A G E N D A

Architectural Review Board

October 26, 2021 – 5:30 p.m.

3A

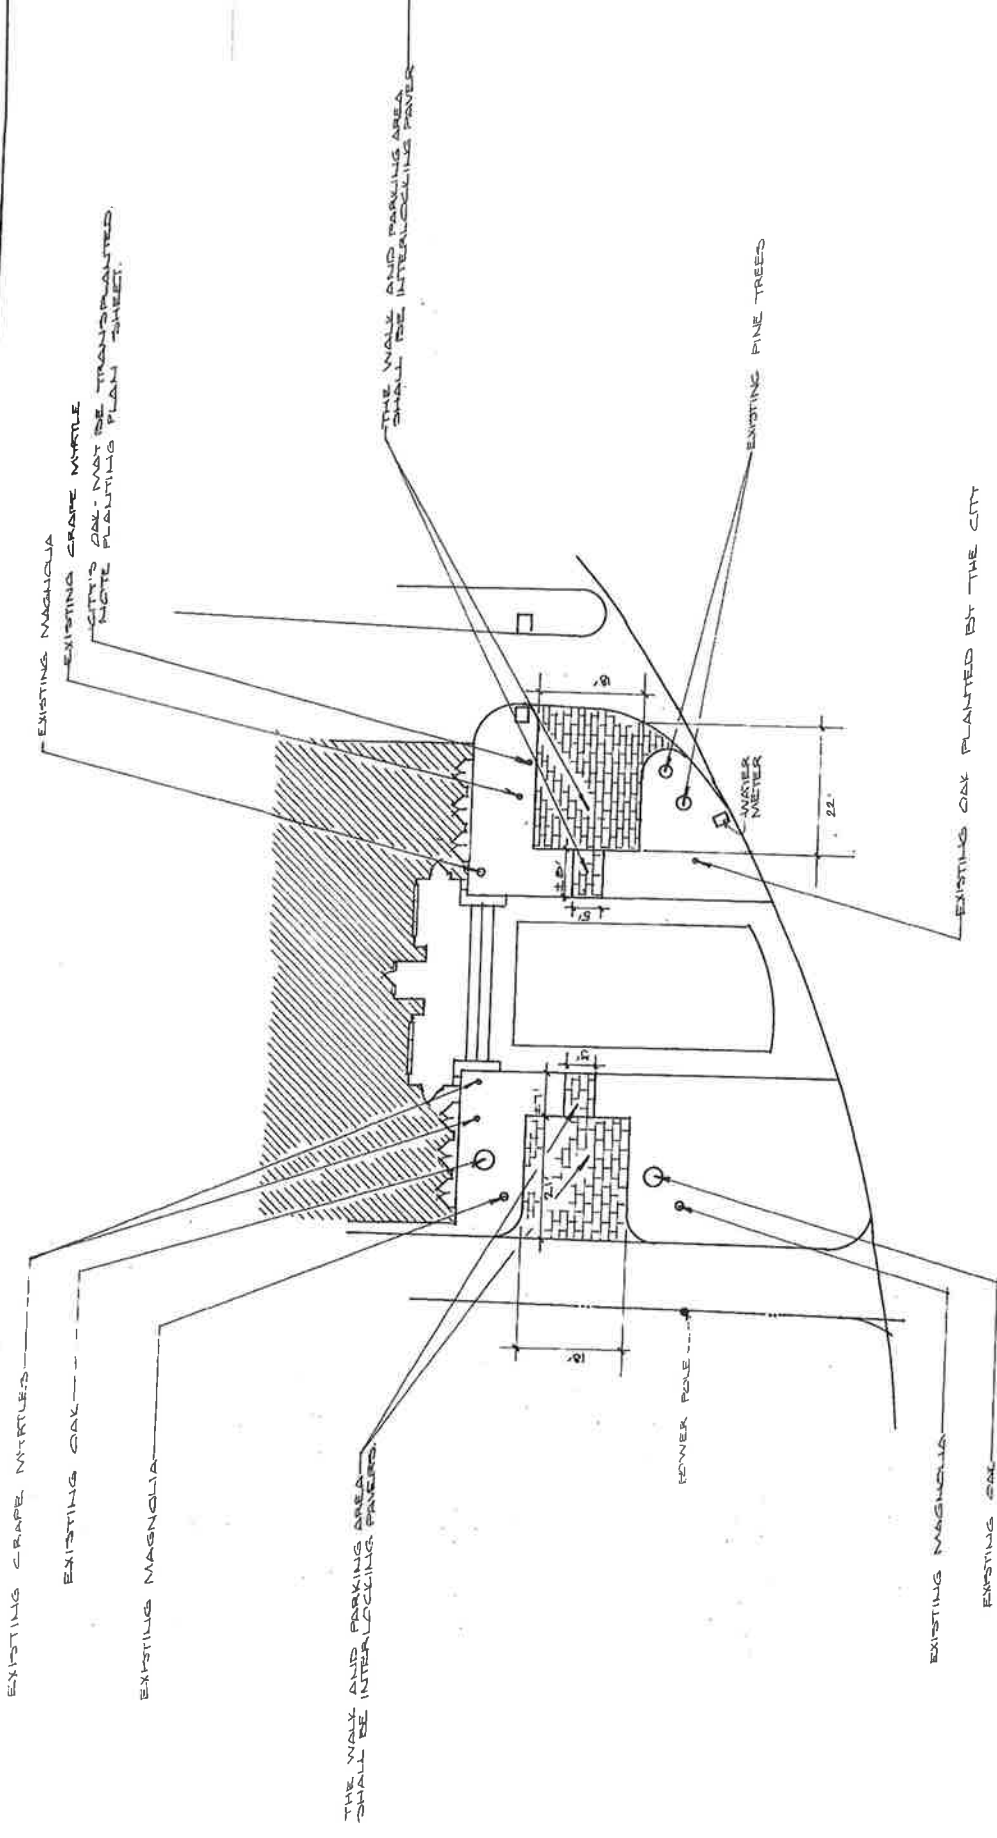
- In the process of reviewing application, we discovered some issues with the site plan. The site plan incorporates approximately 13’ of city ROW into the proposal, and as such, the parking pad on the right hand side, due to the curve of Ridge Avenue at that location, encroaches on the ROW and the large pine trees are City trees, and the landscaping would have to be approved by the Urban Forester.
- The Urban Forester found that approximately half of the right parking pad encroaches on the ROW and puts it within 1 foot of one of the pine trees. Neither tree would survive excavation/construction and a mitigation fee would be required for their loss in order for that portion of the project to move forward.
- Urban Forestry also noted that the oak trees surrounding the parking area would not survive construction, and their removal and replacement would need to be considered.

Site Plan Fencing

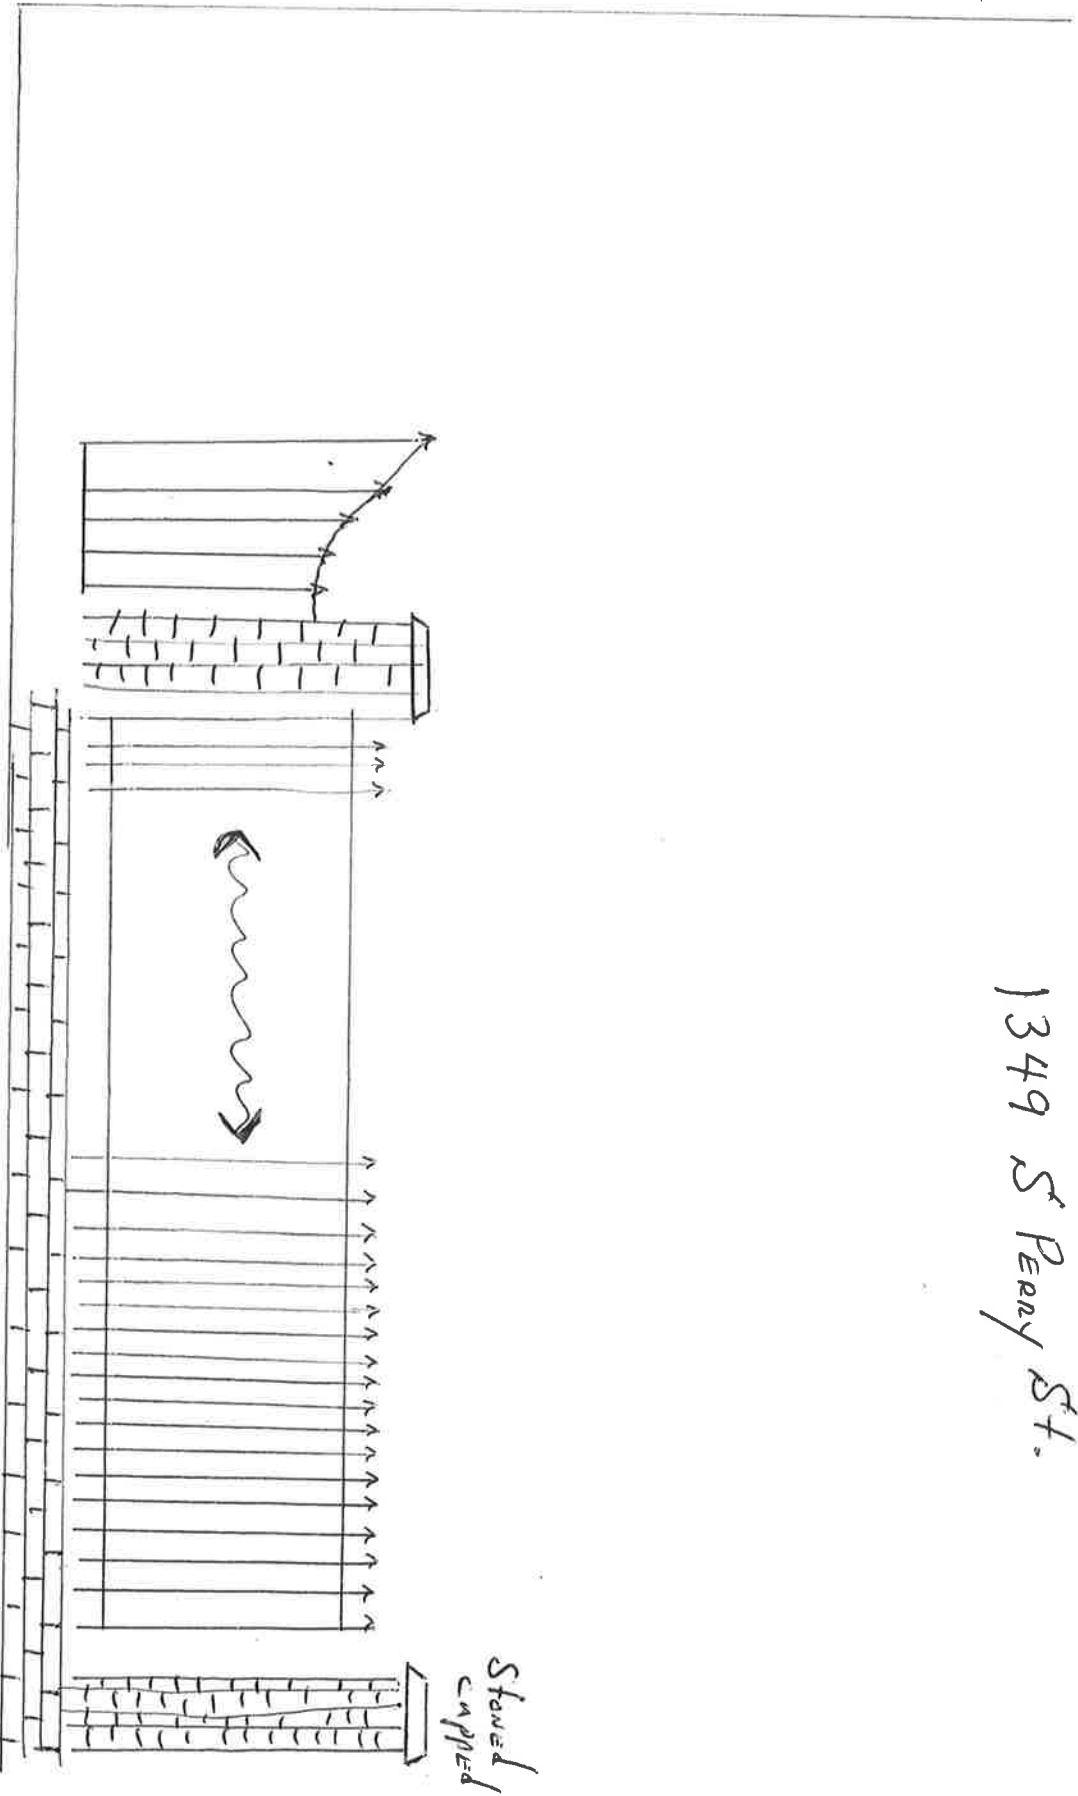
- The solid brick columns will require approval from the Board of Adjustment for encroaching in the required front and street side yard setbacks (if the wall height exceeds 3’ at the north end of the property, it would as well).
- With the proposed driveway gate as part of what the BOA would consider, the gate may need to be moved further up the driveway to allow for a vehicle to completely pull in off the street. If the Board approves the proposal, it is recommend that the approval include some latitude for any adjustments the BOA may require.
- BOA approval required before work can begin.

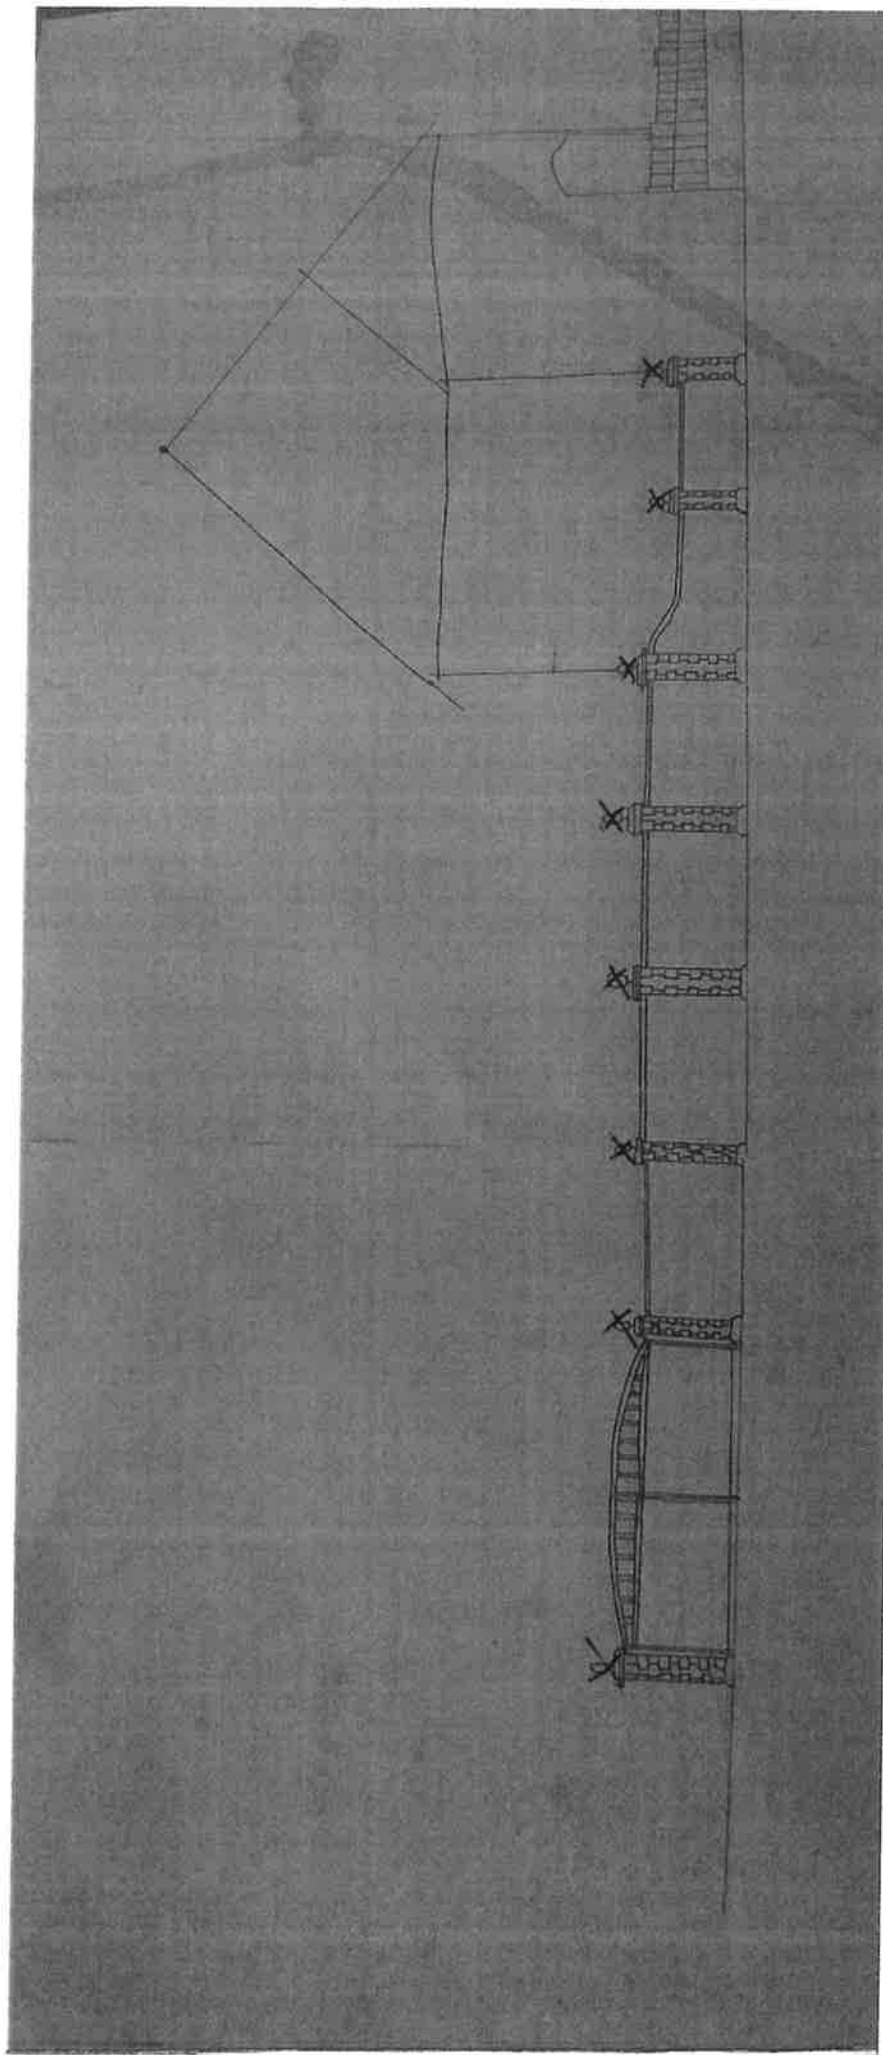
- The recommended height of fences and walls in the historic district guidelines is 6', where 8' is requested.
- This petition will require approval from the Board of Adjustment for an encroachment of a structure greater than 3' high in the required street side yard setback.
- BOA approval required before work can begin.

PROPOSED SITE & DRAINAGE PLAN OF 847 PONCE DE LEON, MONTGOMERY, AL FOR ALL ABOUT CONSTRUCTION

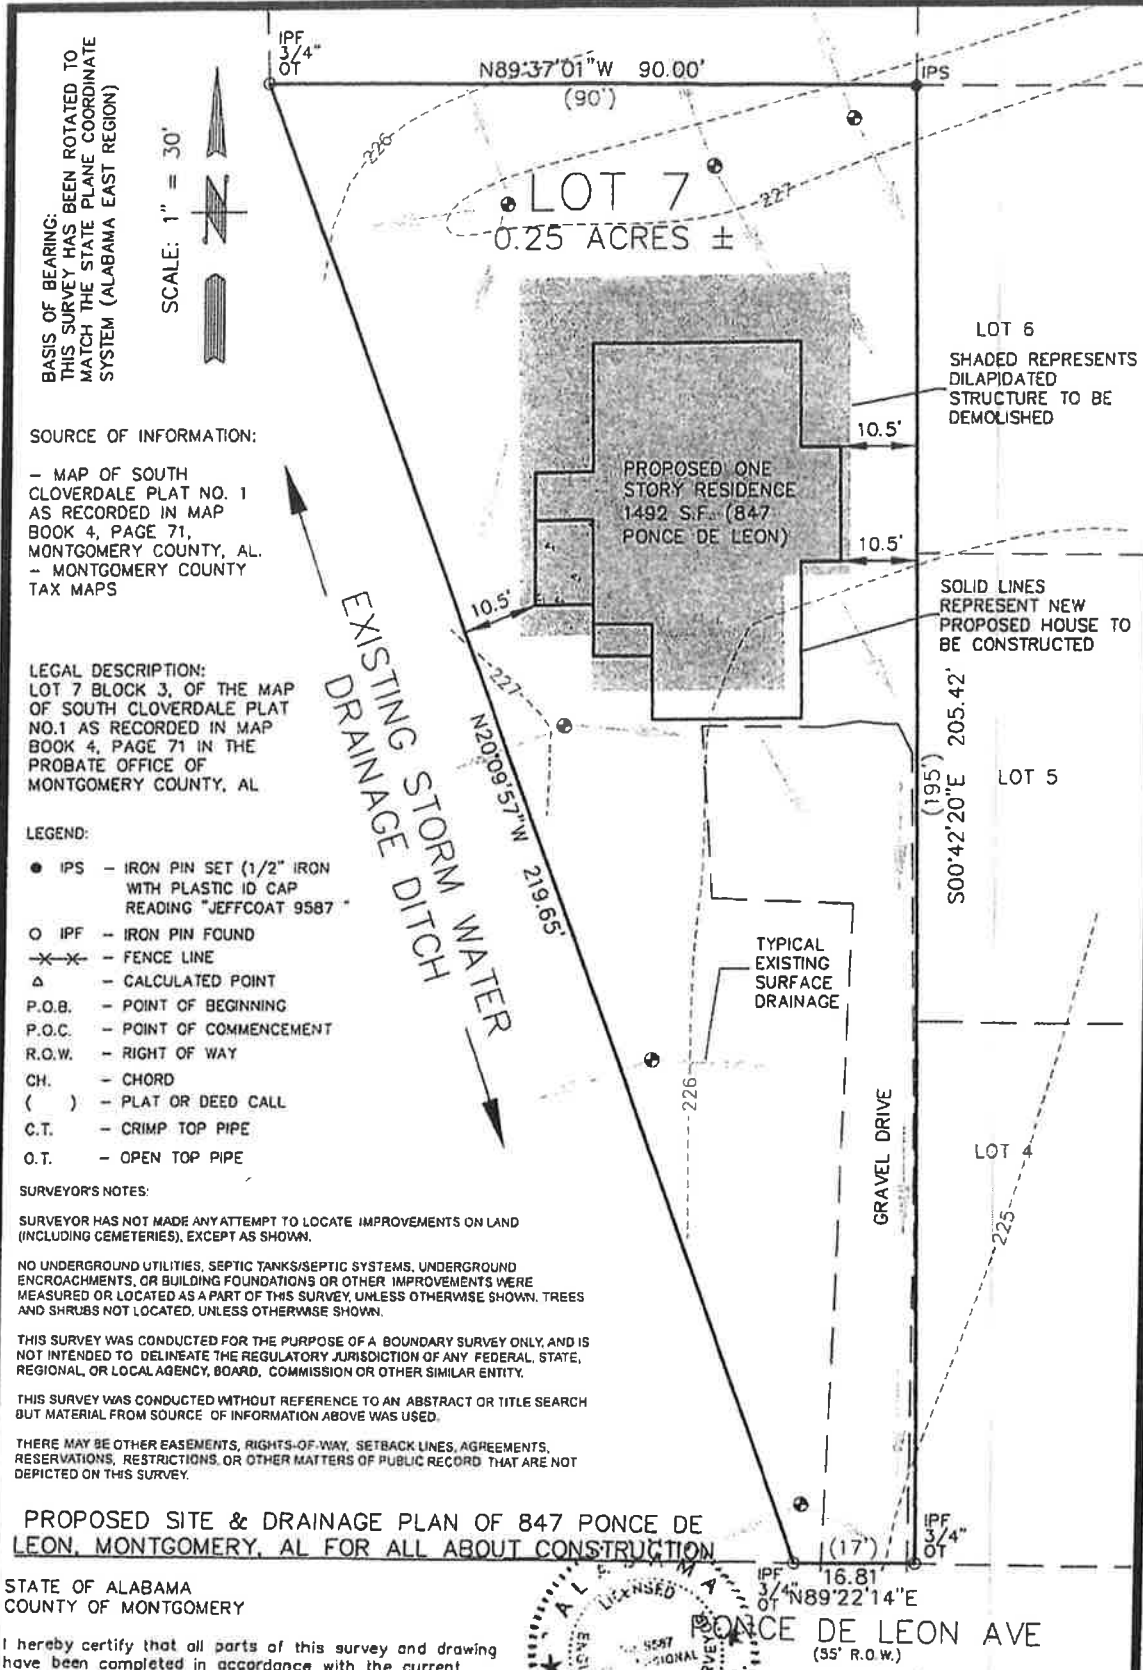
- The first task of the Board is to evaluate the architectural value of the house and the impact of its removal from the streetscape. The house was built in 1950 according to tax records. It does not align with the adjacent properties, it is not visible from the street (so long as the vegetation remains in place), and it has experienced numerous alterations over time to the roof, porch, and a variety of additions. Staff was unable to pinpoint any architectural detail through the alterations, except for the 6:6 wood windows.

- The Board has typically requested new construction be built above grade to at least give the appearance of being constructed on a conventional foundation. The Board may want to consider accessibility issues, particularly if the owners intend to reside in the house.
